STAFF RECOMMENDATION

1101 Holly Street

January 20, 2021

Application: New Construction—Addition

Figure 2: Left Elevation for Proposed Addition at 1101 Holly Street.

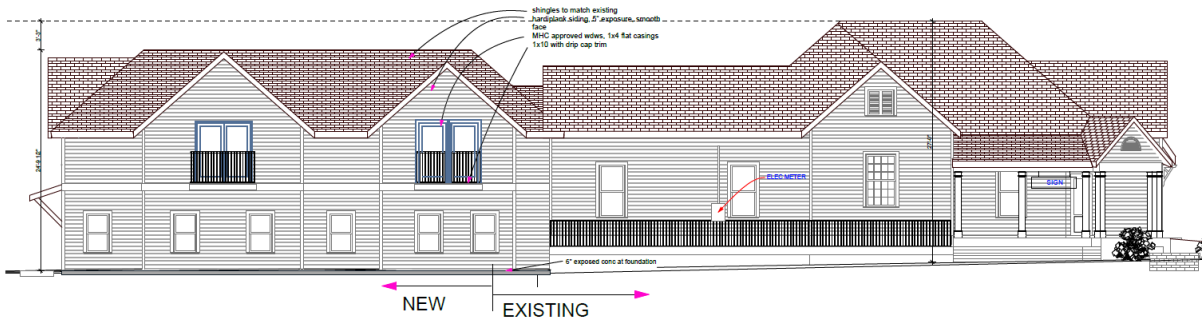
Design: The roof of the addition will be hipped with projecting gables, with the same pitch as the original hip and gabled roof. Although the addition will be shorter with a matching eave height, it will read as having an additional story due to a drop in grade from the front to the rear. In most instances historically, the first level of a building was taller than or the same height as the upper levels. The upperstory is proposed having doors and a balcony on the left elevation facing South 11th Street, taller than the windows on the ground level below. Staff find that this exaggerates the scale of the upperstory and recommends that the window proportions are revised so that the upperstory is subordinate to the ground level.

With a condition that the window proportions on the left elevation are revised, Staff finds that the character of the design is generally compatible with the historic house and meets sections II.B.2.a and II.B.2.f of the design guidelines.

Figure 3. 1101 Holly Street, viewed from South 11th Street.

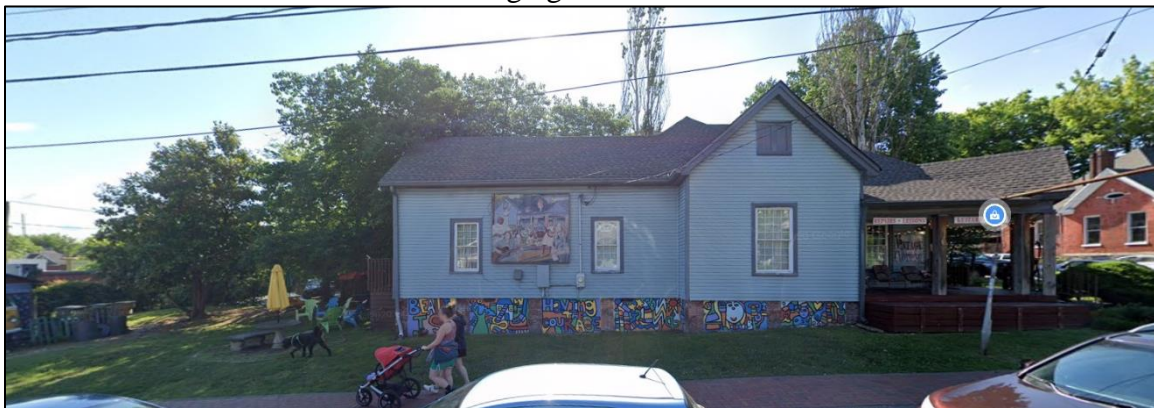
Viewed from South 11th Street, the scale of the addition will be considerable, but Staff finds that it is appropriate for several reasons. One, the addition is not taller or wider than the historic building, and its footprint does not more than double the depth or area of the original building. Second, the form and historic character of the historic building are intact and the addition is designed in such a way that it could be removed without impairing the historic building. Third, while the use of a building does not factor into the appropriateness of design for new construction or an addition, the history of this block does include decades of mixed-use intrusions and adaptive reuse of historic houses. Fourth, the adjacent lot to the rear of this one, which faces South 11th Street, is vacant and will likely have infill with a commercial form on it in the future.

Figure 4: Roof Plan for Proposed Addition at 1101 Holly Street.

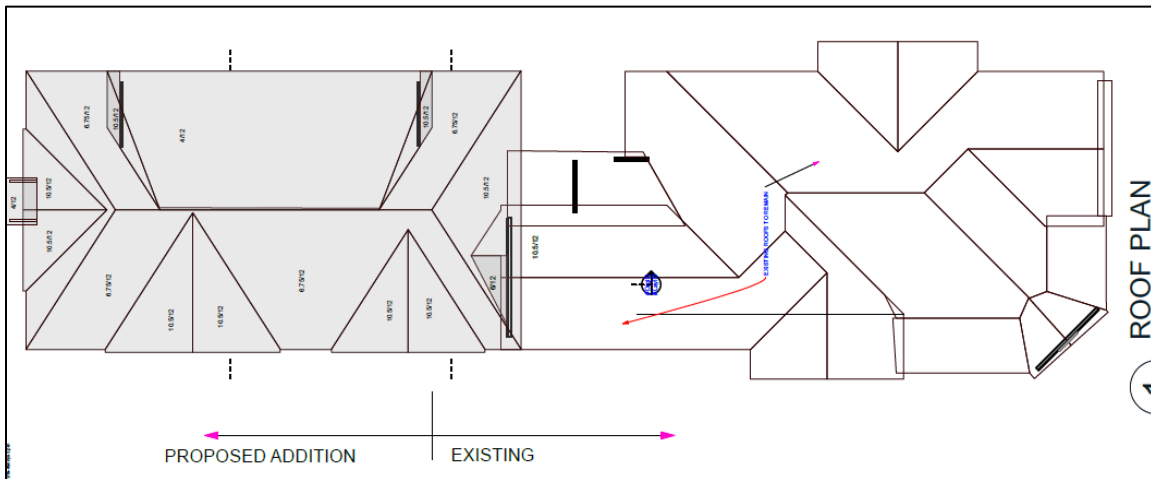
Roof form: The gabled roof of the addition includes a hipped with gable and cross-gabled projections on the left side, and a shed-dormer on the right side. The shed dormer does not step back from the wall below as is typically required, but Staff finds that this dormer will not be greatly visible because of its proximity to the adjacent house to the right, which is a significantly larger two-story house and is zoned OR-20-A. The pitch of the hip and gabled components will match the pitch of the original roof's hip and gabled components.

Staff finds that these roofs are compatible with the historic house and meet section II.B.5 of the design guidelines.

1 LEFT ELEVATION
SCALE: 1" = 10'

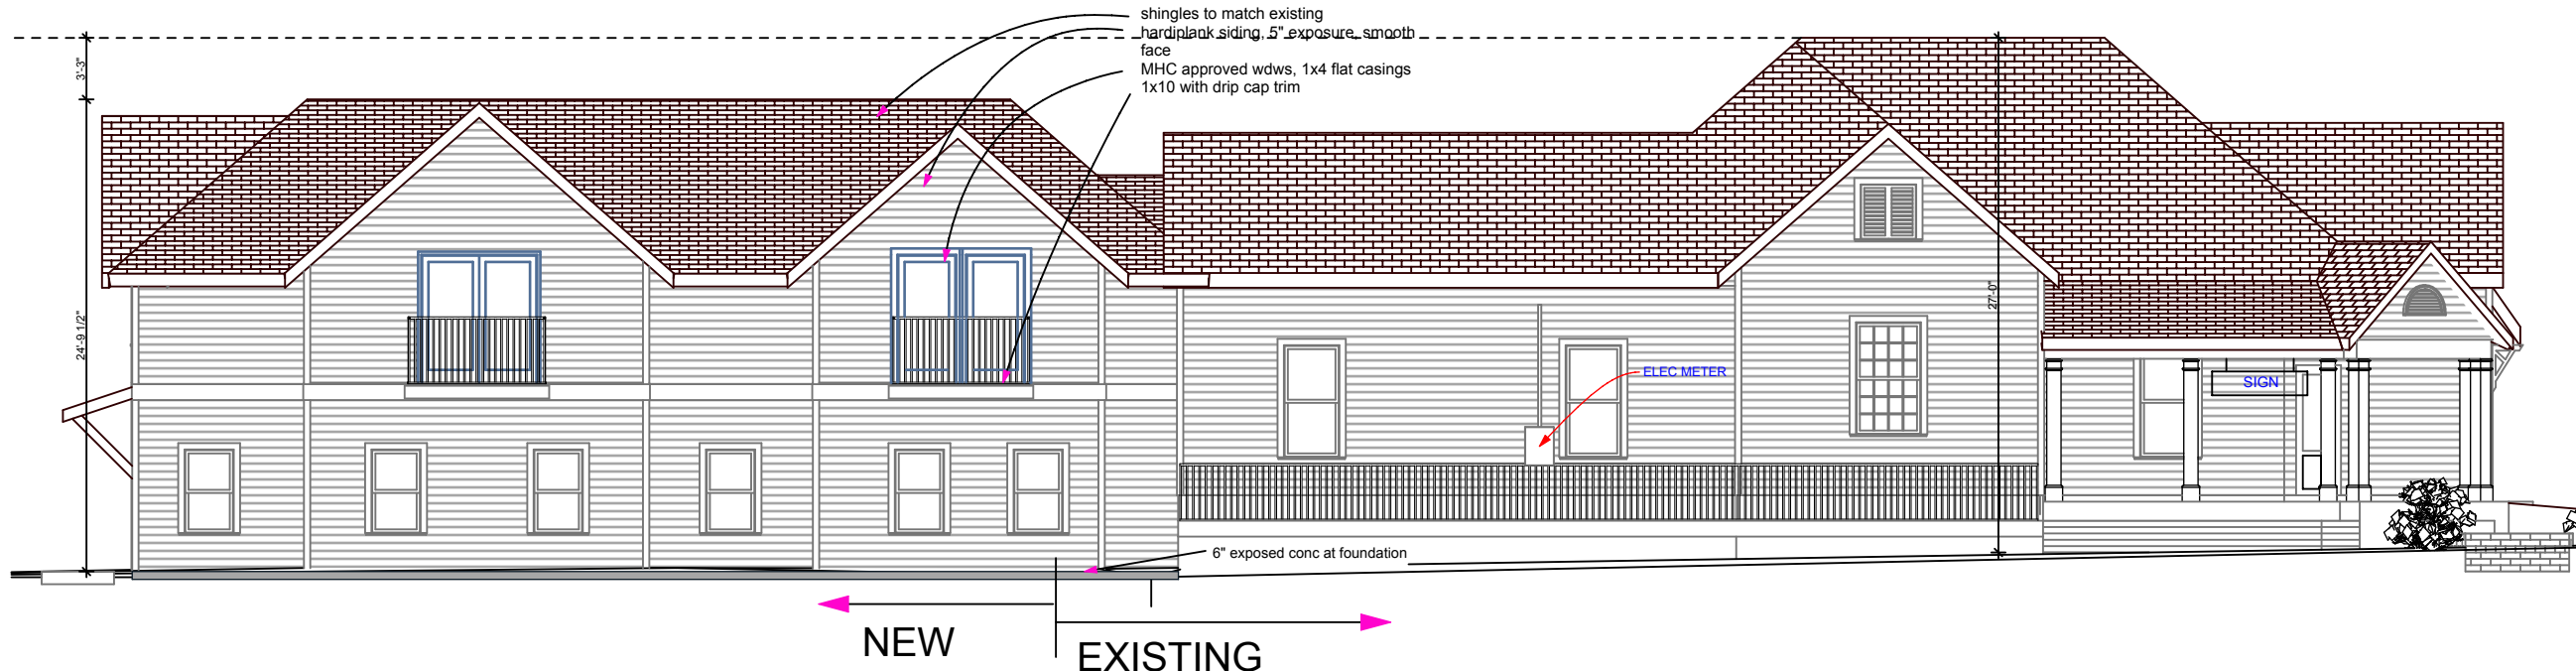
The left elevation of the addition features two projecting gabled bays, similar to a bay on the historic house but taller and wider. Staff recommends that the bays on the addition should match the scale of the bay on the historic house.

As previously described, Staff find that the scale of the upperstory as proposed is exaggerated because its window proportions are greater than those of the ground level. Staff recommends that the scale of the upperstory window proportions are revised so that the upperstory is subordinate to the ground level.

Proportion and Rhythm of Openings: The left elevation of the addition, facing South 11th Street, will have seven evenly-spaced windows on the lower level and two pairs of French Doors on the upper level. While the number and spacing of windows is such that there are no large expanses of walls without an opening, the proportions of the upperstory windows are larger than those of the story below. Staff find that this exaggerates the scale of the upperstory relative to the ground level. Staff recommends that the scale of the upperstory openings are revised so that the upperstory is subordinate to the ground level.

With a condition that the projecting bays on the left side are reduced to match the scale of the original projecting bay and that the window proportions on the left side are revised, Staff finds the scale of the proposed addition to meet sections II.B.1 and II.B.2 of the design guidelines.

With a condition that the window proportions on the left elevation are revised, Staff finds that the window proportion and rhythm of openings are generally compatible with the historic house and that the project will meet section II.B.7 of the design guidelines.

2 RIGHT ELEVATION
SCALE: 1" = 10'

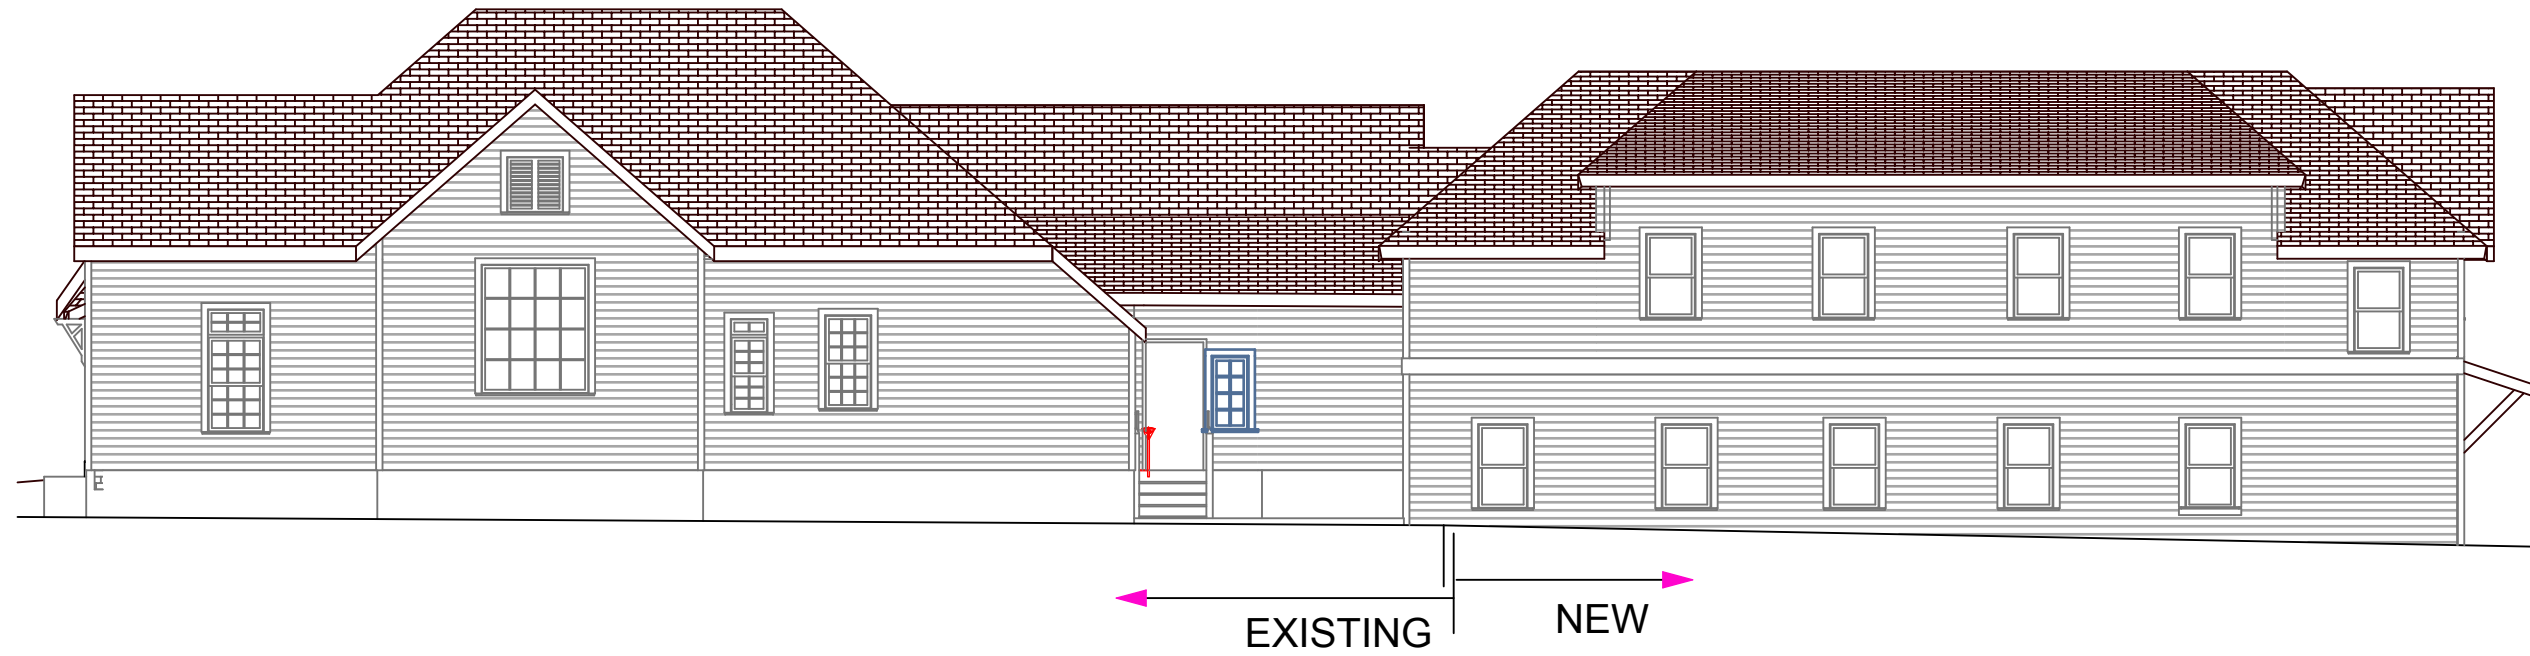
On the right side, both stories have appropriately sized and spaced windows.

Appurtenances & Utilities: The HVAC unit is shown as being located on the right side of the building beyond the midpoint of the building.
